# Flying Pig Systems

## Wholehog II MIDI Input Hardware implementation error & modification

Serial numbers affected: ALL CONSOLES UPTO 05160

Figure 1

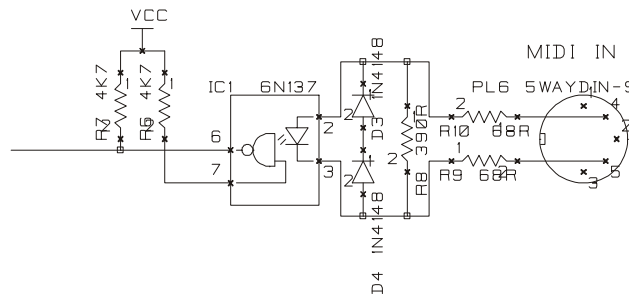
There exists a hardware error in the Wholehog II MIDI Input implementation. Referring to Figure 1 it can be seen that a resistor, R8, exists across the MIDI input signal lines. This resistor should not be there and may cause MIDI receive data errors or no reception at all.

To ensure correct operation this resistor must be removed. Please consult Figure 2 to locate its position on the back panel (I/O) pcb. It is recommended that the resistor simply be cut out without removing the circuit board taking care to ensure that the console is disconnected from the mains supply. It would also be most helpful if you could notify me via email (below) of the serial numbers of any consoles thus modified. Thanks.
